COUNTY OF ALAMEDA

ADDENDUM No. 2

Project No. 2043

**Highland ATR Project - Acute Care Tower AV & TV Systems
Equipment and Installation**

CEILING MOUNTED PROJECTOR

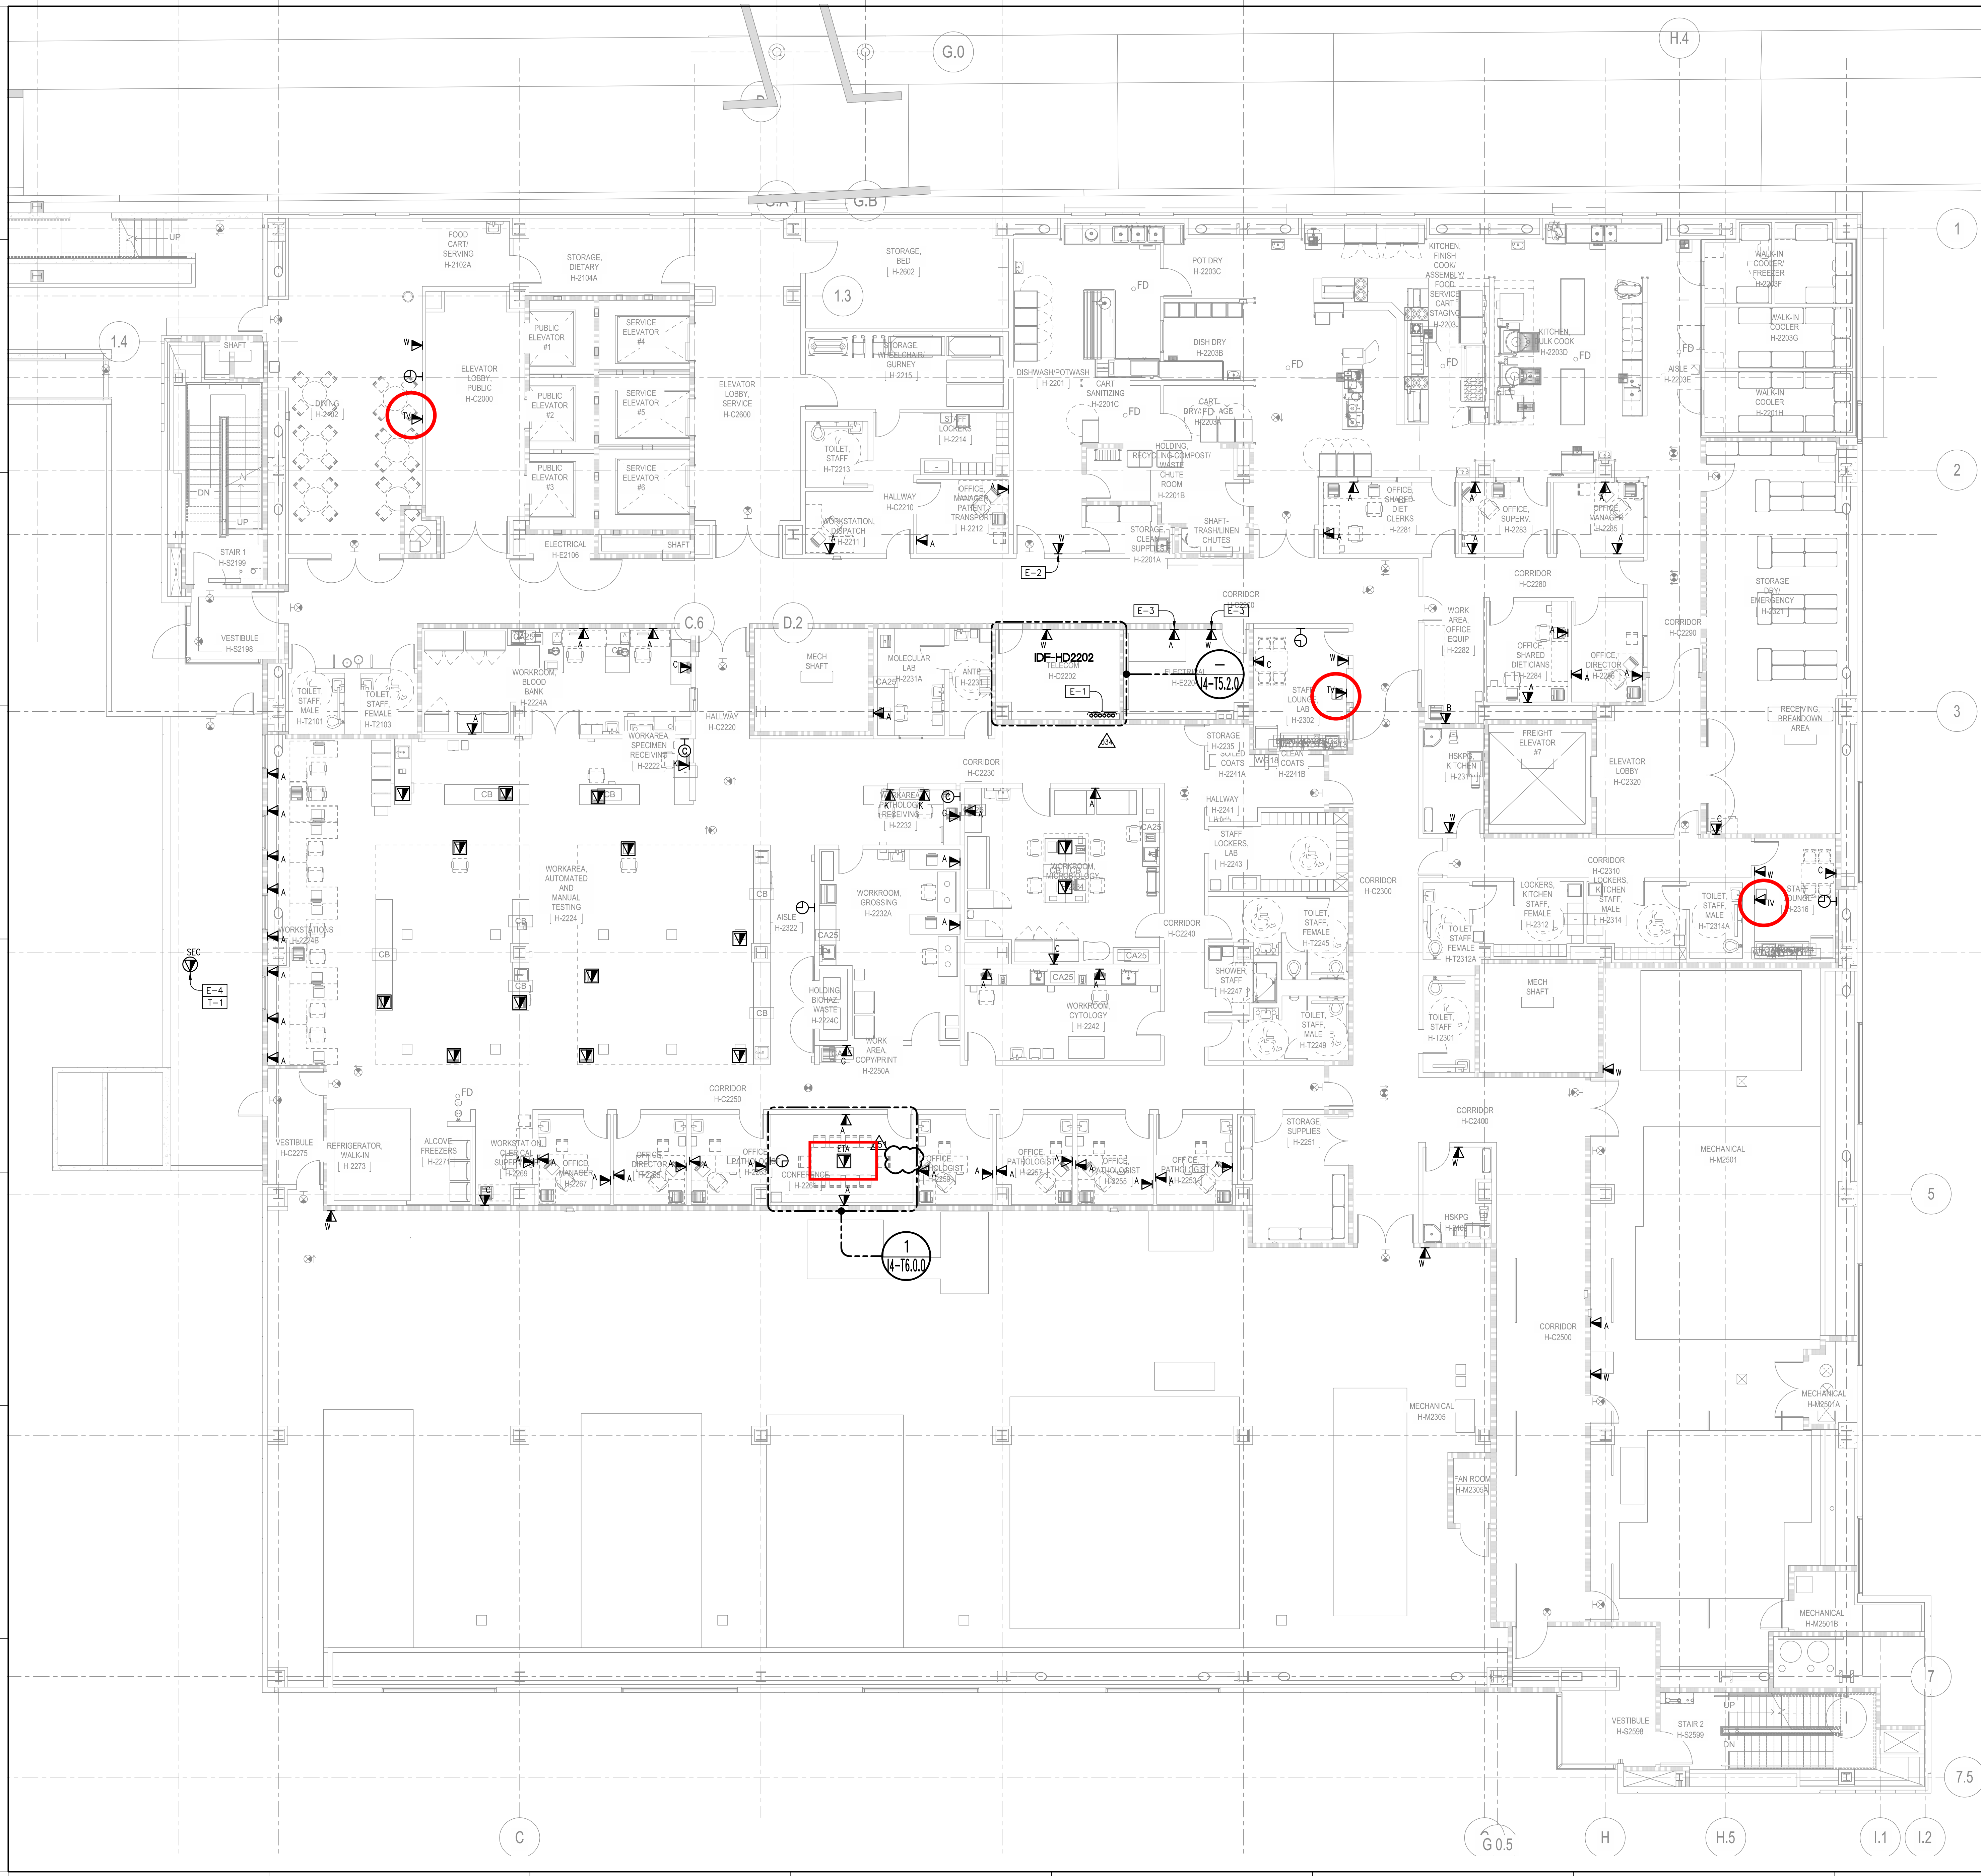
Please see “Attachment A, Ceiling Mounted Projector” detail, included in this Addendum No. 2. This detail is included to clarify the project scope by the AV & TV Equipment and Installation Contractor, and the prior work performed by GSA’s General Contractor: “CDB”.

A4) Yes. Construction Channels, Pole Mount and Plate and Stabilizer Brackets shall be previously installed by others ("CDB"), per "Attachment A, Ceiling Mounted Projector" detail, included in this Addendum No. 2.

NOTE: PROVIDE STRUCTURAL BRACING TO SUPPORT 200 LBS BY CDB

14-T2.2.0

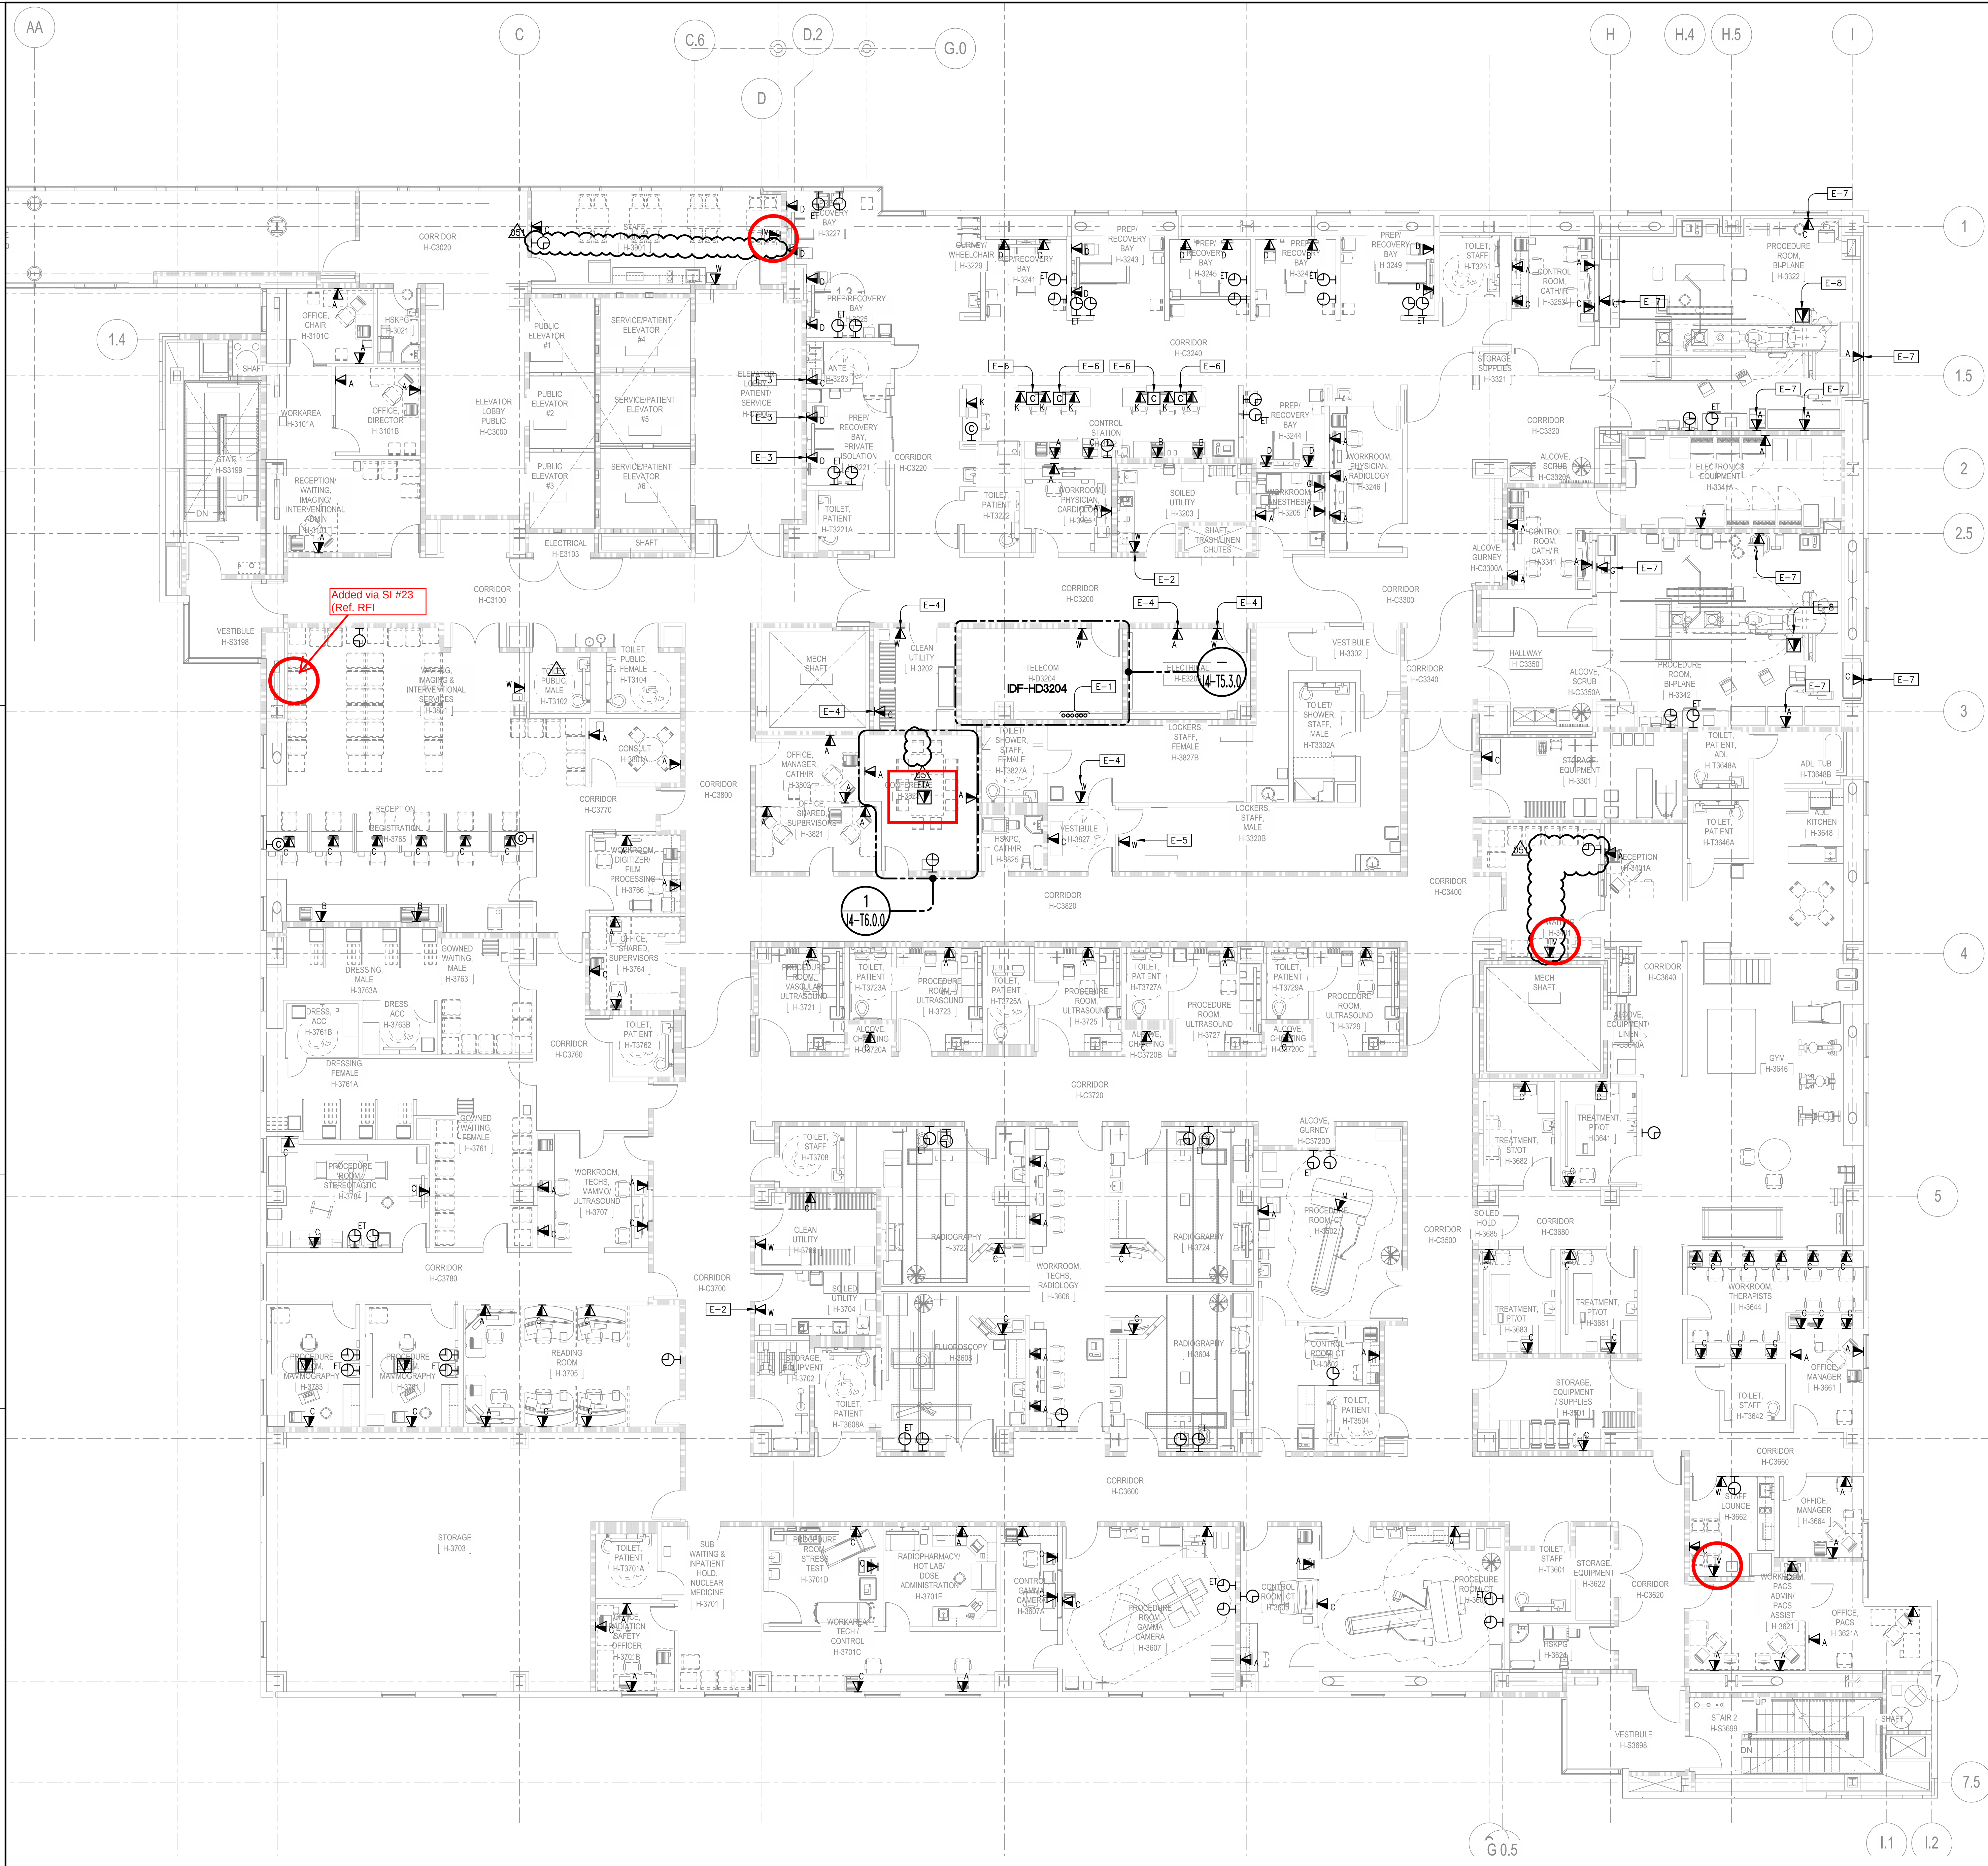
Please see “Attachment B, Telecommunication Drawings” (#2043 Drawings Add2.pdf”) included in this Addendum No. 2. These telecommunication plans now indicate the locations of the AV Projector J-Box in conference rooms on all floor levels of the Acute Care Tower building. Drawings Sheets: I4-T2.1.0, I4-T2.2.0, I4-T2.3.0, I4-T2.4.0, I4-T2.5.0, I4-T2.6.0, I4-T2.7.0, I4-T2.8.0, and I4-T2.9.0.
